S5933QE PCI
Controller Device
Summary

S5933 PCI CONTROLLER DEVICE SUMMARY

**PCI S5933QE Matchmaker Device Summary
Revision 2, November 1, 1997**

**Figure 2**

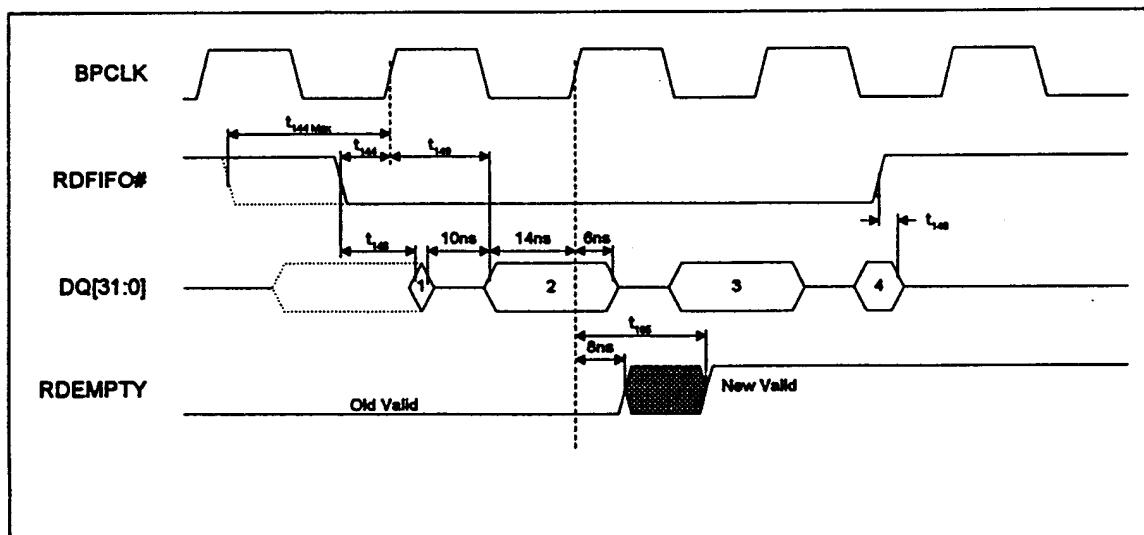
t167 page 13-12 for QC=17ns WRFULL valid from BPCLK rising edge
for QE=11ns

FIFO write: When the Add-on to PCI FIFO is full, WRFULL is asserted 11ns max after the rising edge of BPCLK.

As WRFIFO# requires a 12ns setup, this gives 7ns to de-assert this command before the next BPCLK edge.

Symbol	Parameter	Min	Max	Units	Notes
t_{150}	WRFIFO# Setup to BPCLK Rising Edge	12		ns	
t_{150e}	WRFIFO# Hold Time to BPCLK Rising Edge	0		ns	
t_{151}	DQ(31:0) Setup to BPCLK Rising Edge	7			
t_{151e}	DQ(31:0) Hold from BPCLK Rising Edge	0			
t_{167}	ADD-ON to PCI FIFO WRFULL Valid from BPCLK Rising Edge	6	11	ns	1

**Figure 1**

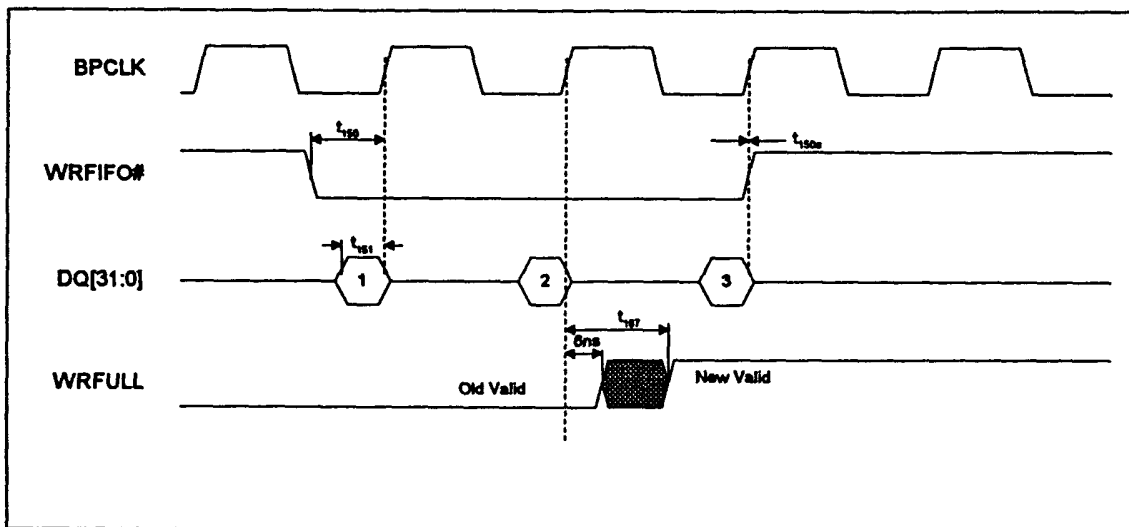
t165 page 13-11 for QC=15ns RDEMPTY valid from BPCLK rising edge
for QE=12ns

Symbol	Parameter	Min	Max	Units	Notes
t_{144}	RDFIFO# Setup to BPCLK Rising Edge	8	26	ns	1
t_{145}	RDFIFO# Low Time	8		ns	
t_{146}	RDFIFO# Low to DQ(31:0) Driven		12	ns	
t_{148}	RDFIFO# High to DQ(31:0) Float		3	ns	
t_{149}	DQ(31:0) Valid from BPCLK Rising Edge		16	ns	3
t_{165}	PCI to ADD-ON FIFO RDEEMPTY Valid from BPCLK Rising Edge	8	12	ns	2

1. Min and Max Times are indicated to allow increased valid data time as shown by dashed lines.
2. State change of RDEEMPTY shown below is reference only. Actual change would indicate no Data 3 available.
3. Valid applies after first access. First access is async with following as sync accesses.
